Re: **Davis Development Multifamily at Lamar Landing – Site Plan and Plat.**
Application Number: **DA-2239-02**

Initial Submission Review

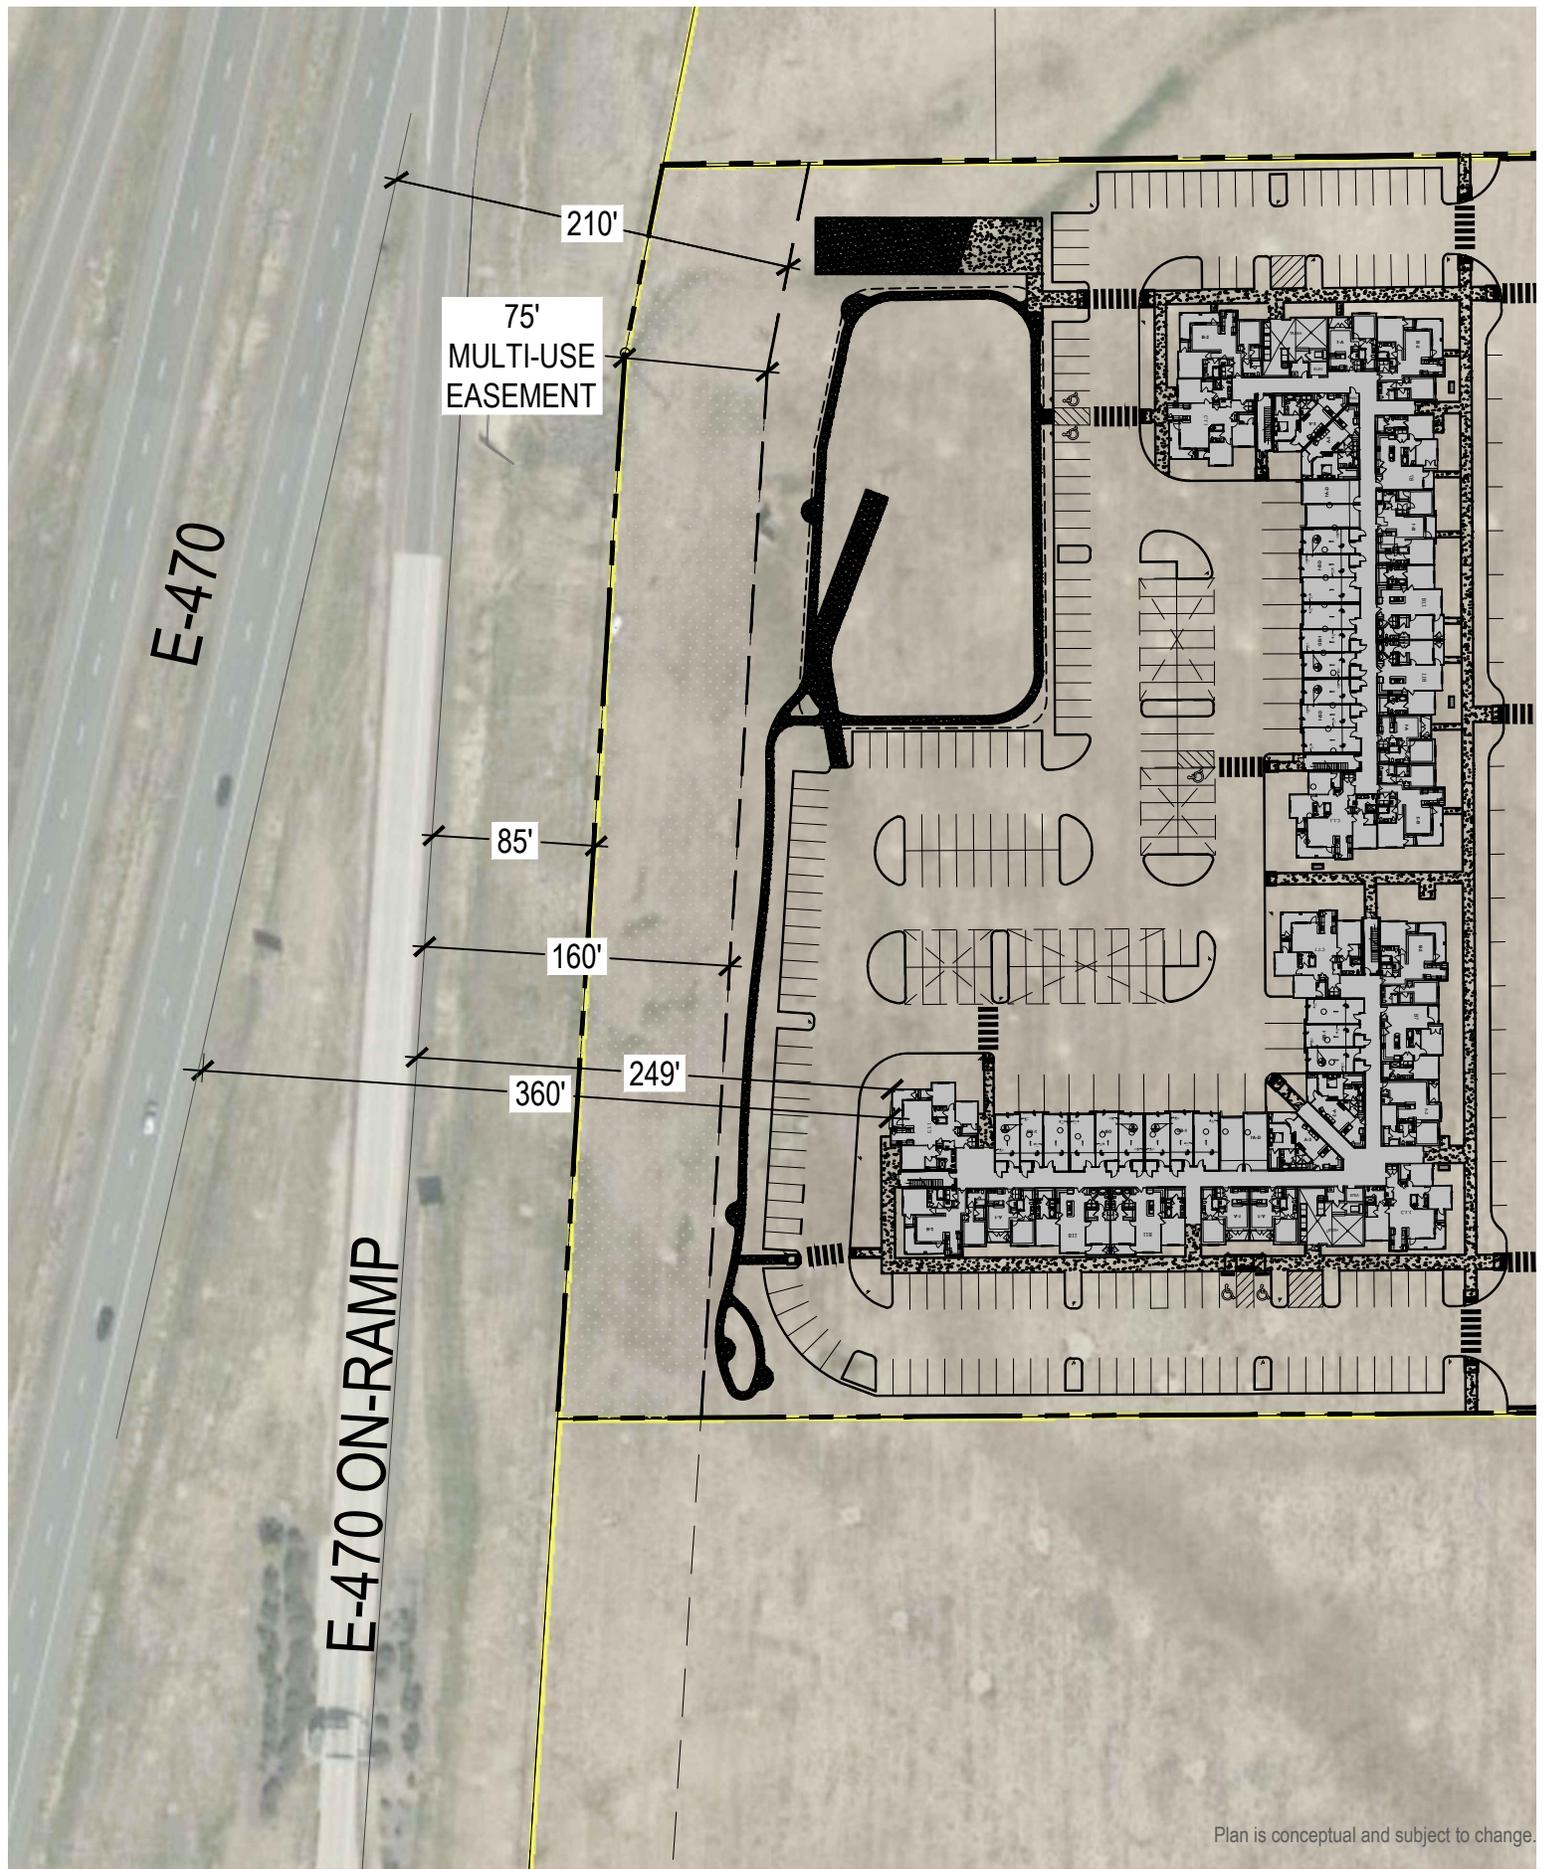
8J. A sound attenuation wall is required adjacent to E-470 unless an adjustment is being requested and hardship is expressed.

Response: The Aurora UDO calls for sound attenuation walls for residential developments adjacent to E-470 to meet requirements for fences and walls along arterial streets. Standards for residential development along arterial street state:

Sec. 4.7.9.H.1.a. "Where the rear lots of residential homes front a street, fence and/or walls shall be set back a minimum of 40 feet from the flow line of arterial streets,"

The site's western boundary line (excluding the 75' multi-use easement) is 160 feet from the flow line of the northbound E470 on-ramp at the closest point, and 210 feet from the flow lines of the main body of the highway at the closest point. (Please see the exhibit on the following page.) The site is physically buffered from the highway by a 75' multi-use easement, and visually and auditorily buffered by a 25' wide landscape buffer which includes 20 trees and 204 shrubs.

With that in mind, the applicant believes that the intent of the UDO to provide sound attenuation and visual buffer of E-470 from adjacent residential homes is already met by the significant distance from the road and the provided landscape buffer.
